Staff Report & Recommendations

Clark Public Utilities (CPU) Flow Station: Type II Site Plan Review

(#2022-023-SPR) August 4, 2022

PROPOSAL:	The applicant is proposing to upgrade the existing CPU flow station near the intersection of NE Timmen Road and La Center Road with new pressure reducing valves and flow valves inside a new above ground 10.5-foot wide by 16-foot long by 10-foot tall pre-manufactured concrete utility building structure. The total new hard surfacing will include 168 square feet of roof area, 158 square feet of concrete sidewalk (on the south and east side of the building), and approximately 576 square feet of gravel driveway for a total of 902 square feet of new impervious surfacing. Total earthwork is estimated at approximately 25 cubic yards.
LOCATION:	<ul style="list-style-type: none">▪ No site addresses.▪ The project is located within the City of La Center right-of-way, north of intersection of NW La Center Road and NW Timmen Road.
HEARING:	Not required for a Type II procedure
APPLICABLE STANDARDS	La Center Municipal Code (LCMC) Title 18, Development Code: Type II Procedure, 18.30.090; Notices, 18.30.120; Mixed-use District, 18.165; Site Plan Review, 18.21

SHEET 2
EXISTING CONDITIONS

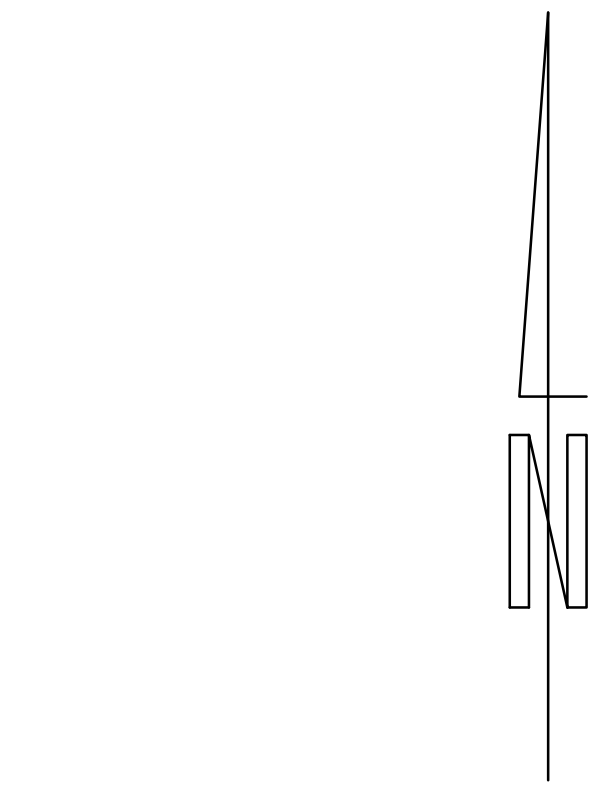
- *An existing conditions plan drawn to a minimum scale of one inch equals 200 feet on a sheet no larger than 24 inches by 36 inches.*
 - Status: **Complete**. Sheet 2 of the applicant's plan set is the existing conditions plan.
